Access Compliance Report Public Rights-of-Way (Curb Ramps)

Main Street: COPA_DE_ORO_DR		Cross Street: MONTECITO_RD		Location:	SE
ADA ID: RPRK211209111426	Ramp Type:Type 1 - Perpendicular	Initial Pass/Fail: Fail	Overall Compliance: No	Severity Score:	2
Codes/Mitigation Info/Possible Solution			Field Measurements/Component Compliance

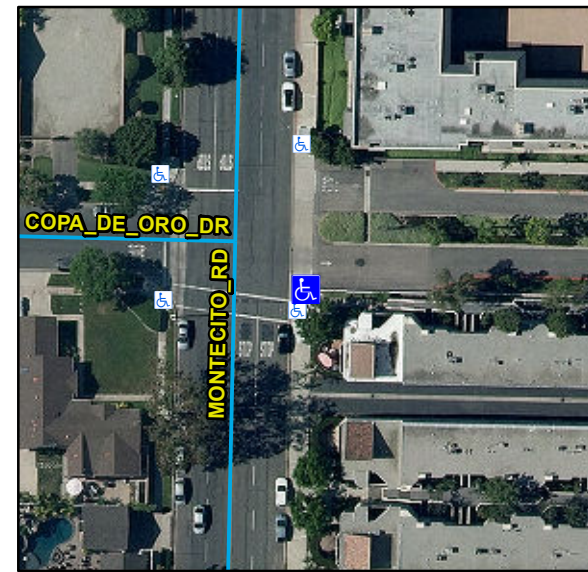
Compliance	Description	Data	Compliance	Description	Data
N/A	Ramp Length (in)	97	N/A	Flare Type LT	
Yes	Ramp Width (in)	50			N/A
Yes	Ramp Run Slope (%)	4.3	N/A	Flare Slope LT (%)	N/A
No	Ramp Cross Slope (%)	4.2	N/A	Flare Traversable LT	N/A
N/A	Landing Present	N/A	N/A	Flare Type RT	
N/A	Landing Length (in)	N/A			N/A
N/A	Landing Width (in)	N/A	N/A	Flare Slope RT (%)	N/A
N/A	Landing Run Slope (%)	N/A	N/A	Flare Traversable RT	N/A
N/A	Landing Cross Slope (%)	N/A	N/A	DWS Provided	N/A
N/A	Landing Movement Obstructed?	N/A	N/A	DWS Contrast	N/A
	Landing Movement Type	N/A	N/A	DWS Length (in)	N/A
N/A	Landing Shared	N/A	N/A	DWS Full Width	N/A
N/A	Clear Space	N/A	N/A	DWS Offset Left (in)	N/A
N/A	Clear Space To Crosswalk (in)	N/A	N/A	DWS Offset Right (in)	N/A
N/A	Marked Crosswalk 1	No	N/A	Marked Crosswalk 2	N/A
	Crossing 1 Direction	N		Crossing 2 Direction	N/A
	Marked Crosswalk 1 Width (in)	N/A		Marked Crosswalk 2 Width (in)	N/A

Remove & Replace Entire Ramp.

R304.5.3, STD 1115
